Mountain Valley Pipeline, LLC
Mountain Valley Pipeline Project
Docket No. CP16-10-000

**Responses to FERC Staff’s Recommended Mitigation
in Final Environmental Impact Statement**

16. **Prior to construction**, Mountain Valley shall file with the Secretary, for review and approval by the Director of OEP, a segment-specific construction and operation access plan for the area between MP 237.6 and 240.3, that does not include access road MVP-RO-279.01. (*section 3.5.1.12*)

**ATTACHMENT 1:
STREAMS AND WETLANDS BETWEEN
ACCESS ROAD MVP-MLV-AR-028 AND
HONEYSUCKLE ROAD**

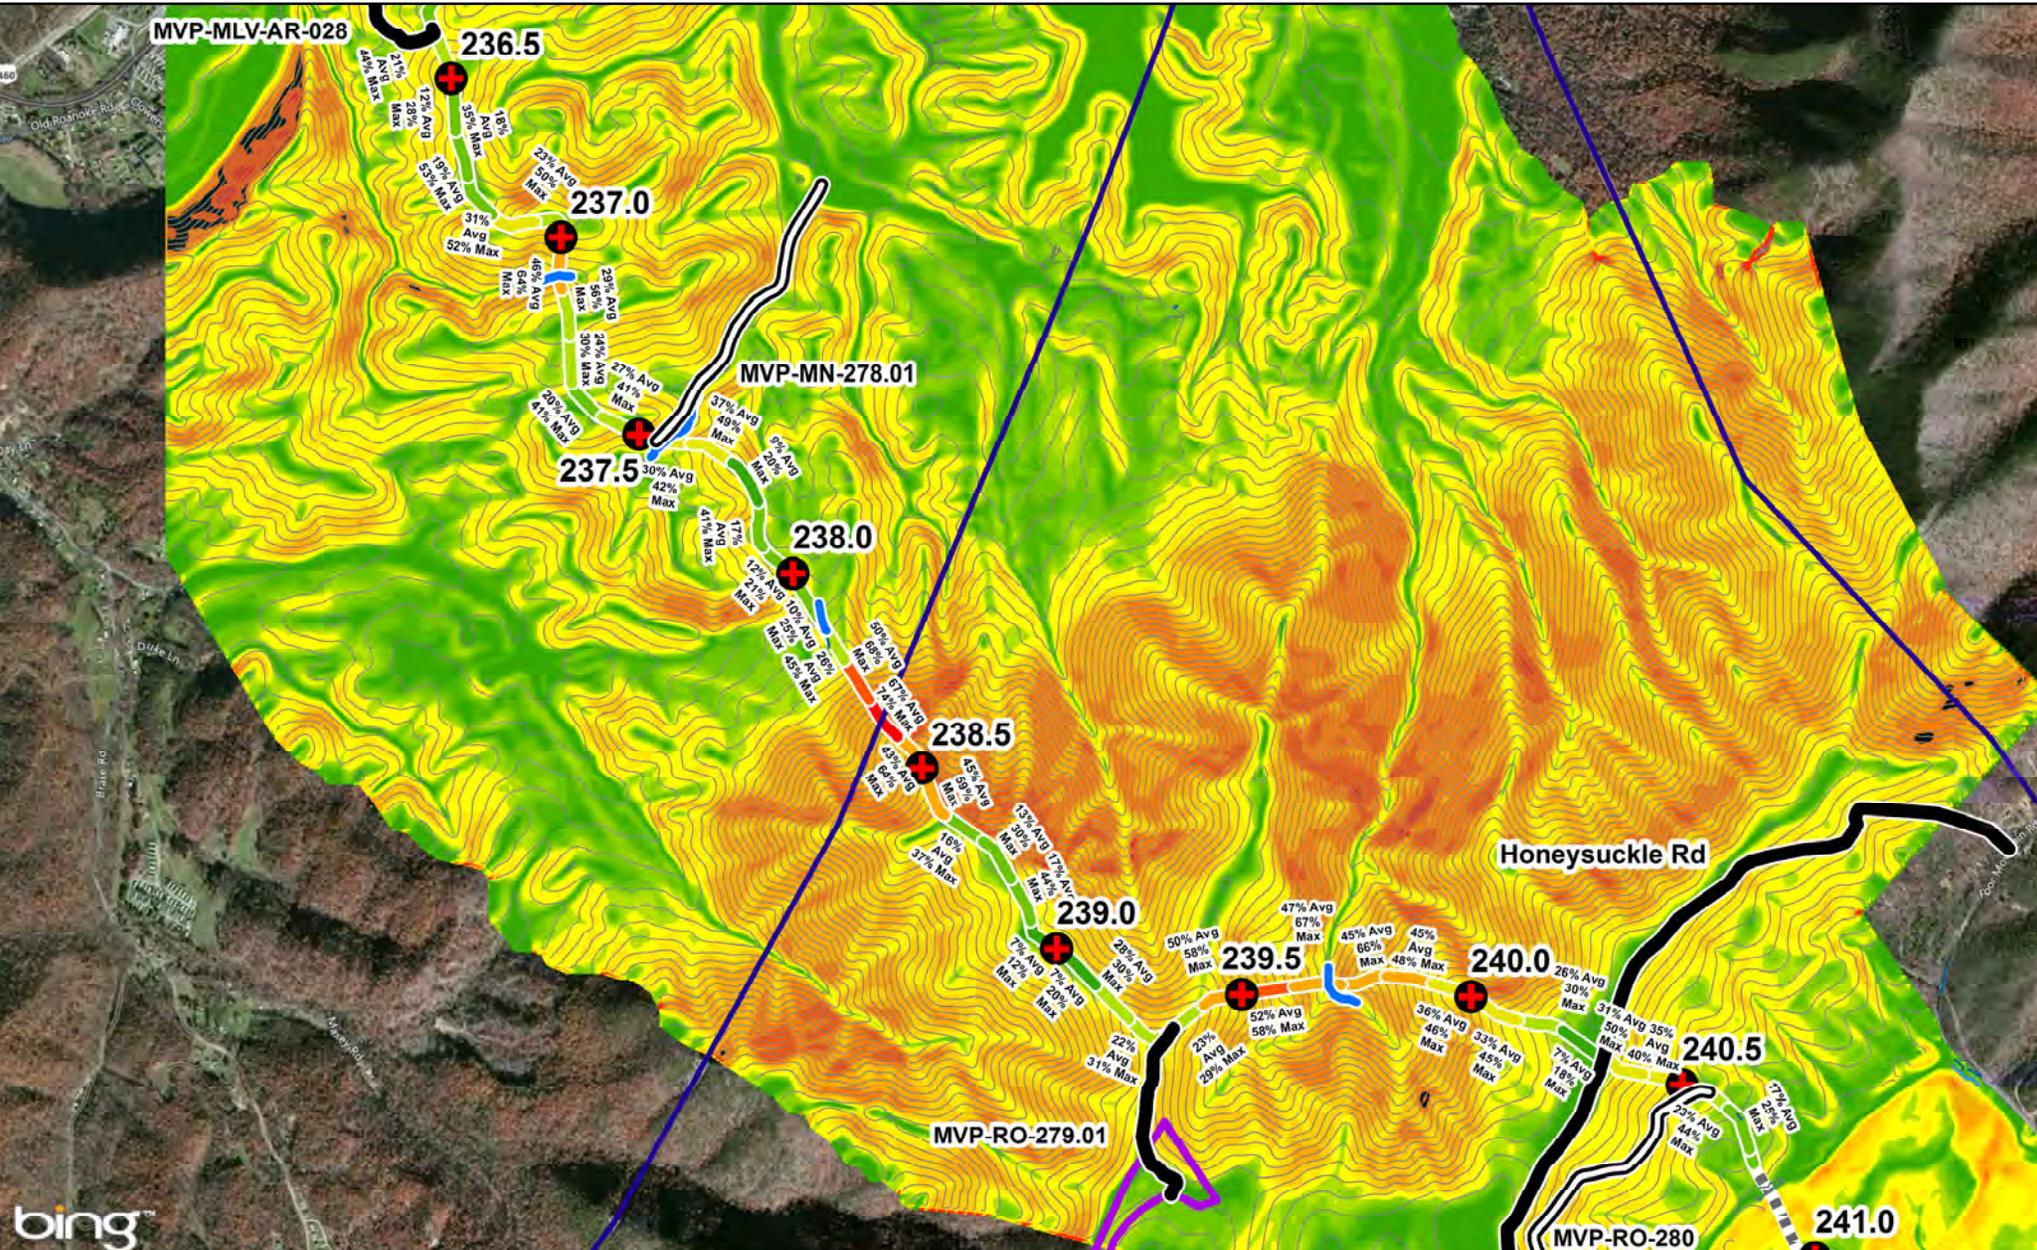
028 (milepost 236.4) and to the south via Honeysuckle Road (milepost 240.3), which is a public road. Attachment 1 shows there are four streams and one wetland located on the right-of-way itself between permanent access road MVP-MLV-AR-028 and Honeysuckle Road. Without the use of access road MVP-RO-279.01, access for maintenance personnel or emergency responders requires unnecessary crossings and associated impacts to these streams and wetlands, increased response time due to the crossings, and winching or aerial techniques and associated impacts. Mountain Valley’s use of access road MVP-RO-279.01 would minimize these impacts and decrease response time.

**ATTACHMENT 2:
SLOPES OF ROW AND
SURROUNDING AREA**

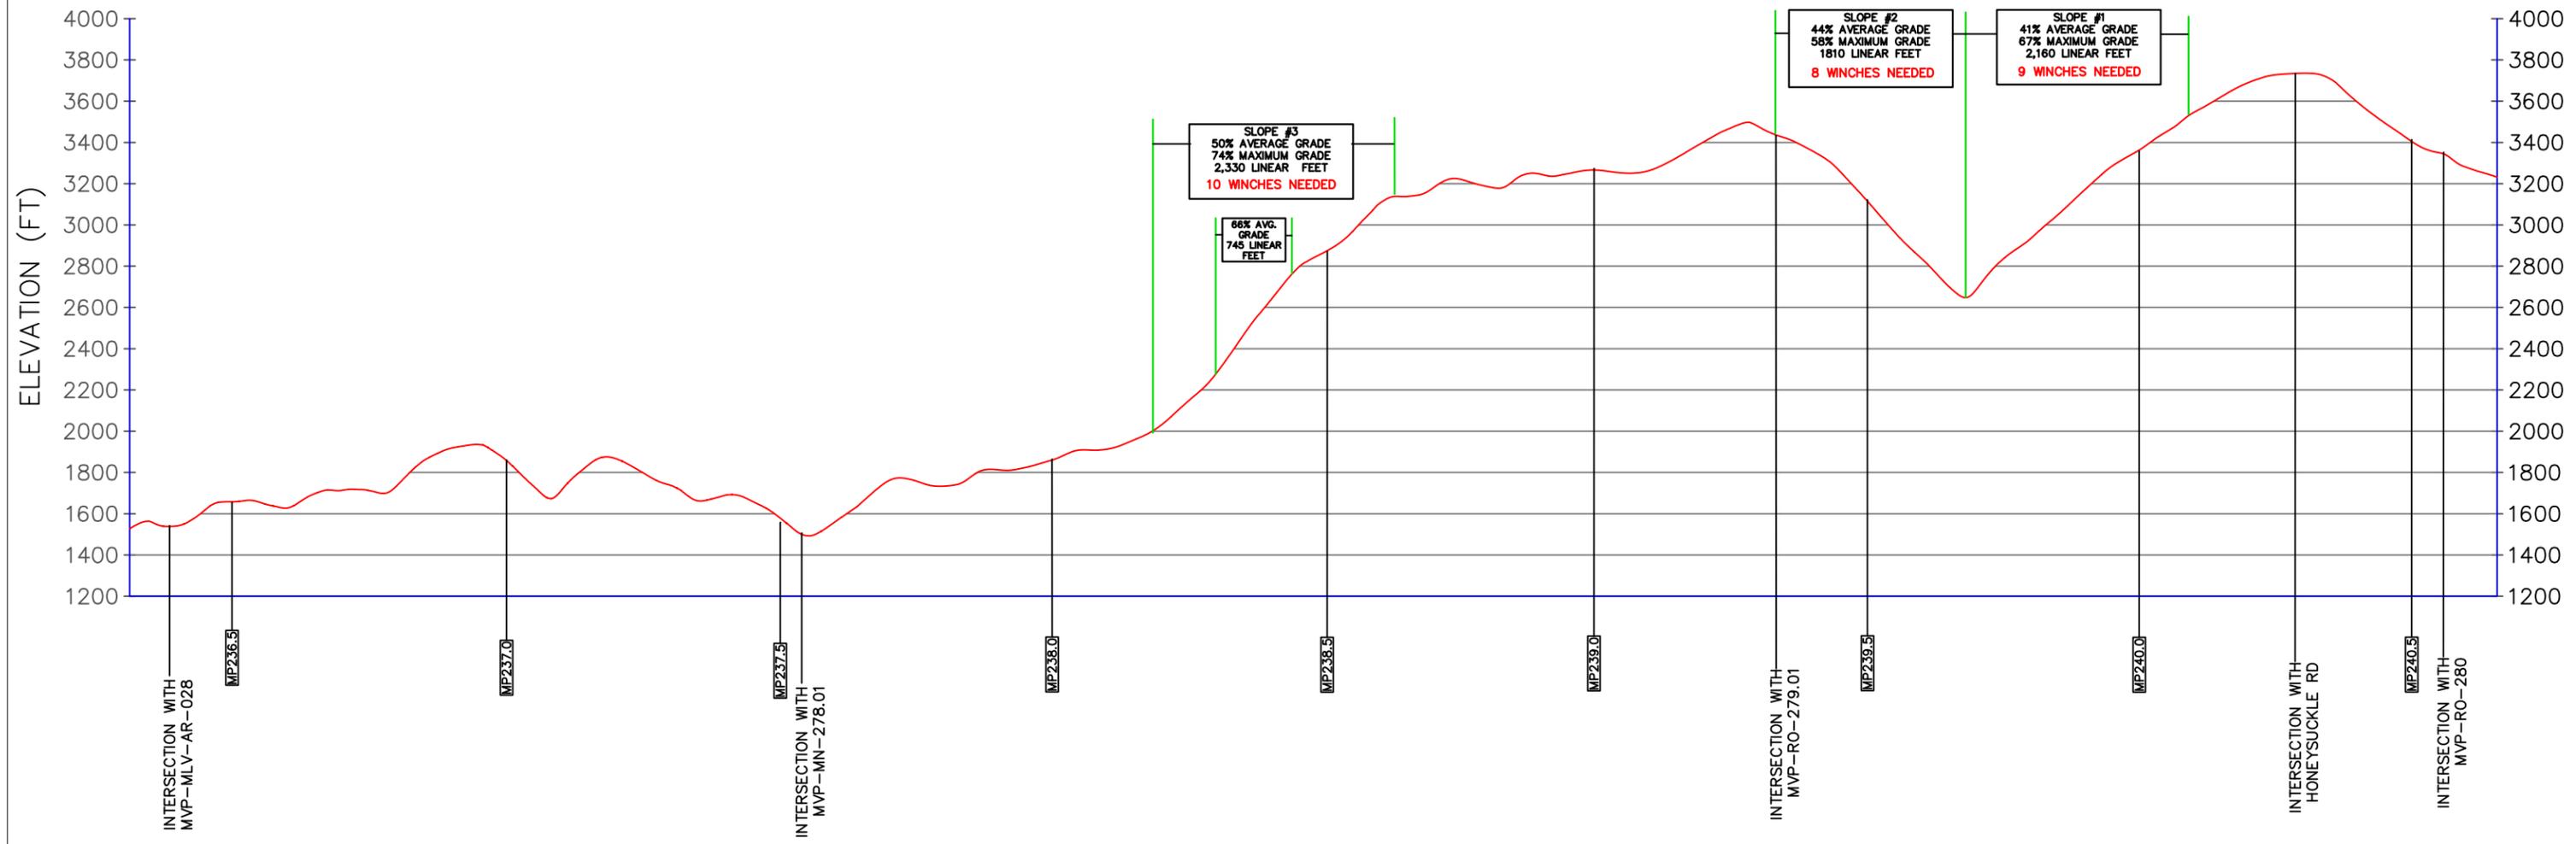
Commission approval of Mountain Valley’s use of access road MVP-RO-279.01 would significantly increase Project safety. To illustrate the construction and engineering challenges as well as the techniques that would be necessary without the use of access road MVP-RO-279.01, Mountain Valley has included two figures that show the slope percentages (Attachment 2) and elevation profile (Attachment 3) of the right-of-way in the relevant area. Without the use of access road MVP-RO-279.01, material, equipment, fuel, and workers must access the right-of-way using access roads MVP-MN-278.01 (milepost 237.5) and MVP-RO-280 (milepost 240.5) or aurally during construction. As shown in Attachment 2, the right-of-way and the surrounding area are steeply sloped. Consequently, the surrounding topography is not conducive to access roads other than MVP-RO-279.01³ and using the right-of-way for access requires techniques for sloped areas. The steeply sloped nature of the right-of-way is further shown in Attachment 3.

**ATTACHMENT 4:
MVP-RO-279.01
REPRESENTATIVE DRAWING -
PROPOSED ACCESS ROAD UPGRADES**

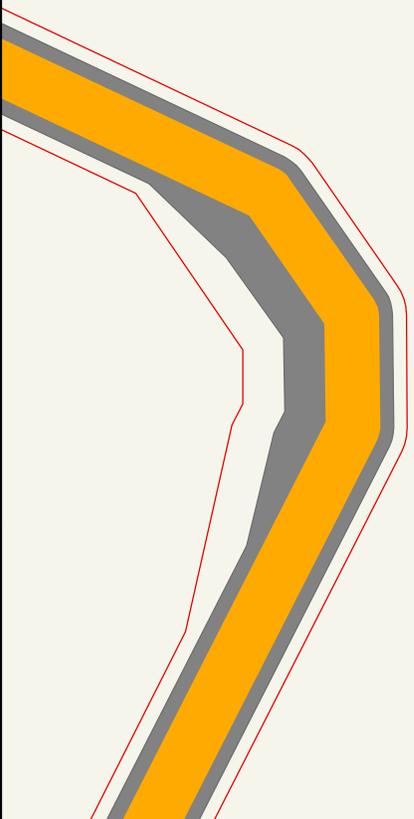
the road to one-way traffic instead of two-way traffic, Mountain Valley is proposing to do so to emphasize the importance of this access road to Project safety. Mountain Valley is amenable to upgrading and widening the existing road only to the extent necessary to permit passage of equipment and materials to the right-of-way.⁶ Attachment 4 includes a representative drawing for narrowing access road MVP-RO-279.01. Mountain Valley believes it can narrow the access road (inclusive of the width of the existing road) to 15 feet on straight portions and 20 feet on curved portions⁷ and narrow the workspace to 20 feet on straight portions and 30 feet on curved portions.⁸ However, the widths shown in Attachment 4 are only estimates because Mountain Valley is unable to perform additional surveys to provide more detailed information. Mountain Valley proposes to work with Commission Staff to provide a site-specific drawing for approval prior to construction. To memorialize this commitment, Mountain Valley proposes that the Commission replace Recommended Condition 16 with the following in the Certificate Order:

16. **Prior to construction**, Mountain Valley shall file with the Secretary, for review and approval by the Director of OEP, a site-specific drawing for access road MVP-RO-279.01 and justification for road widths that exceed 15 feet for straight portions and 20 feet for curved portions, and justification for workspace widths that exceed 20 feet for straight portions and 30 feet for curved portions, for access road MVP-RO-279.01.
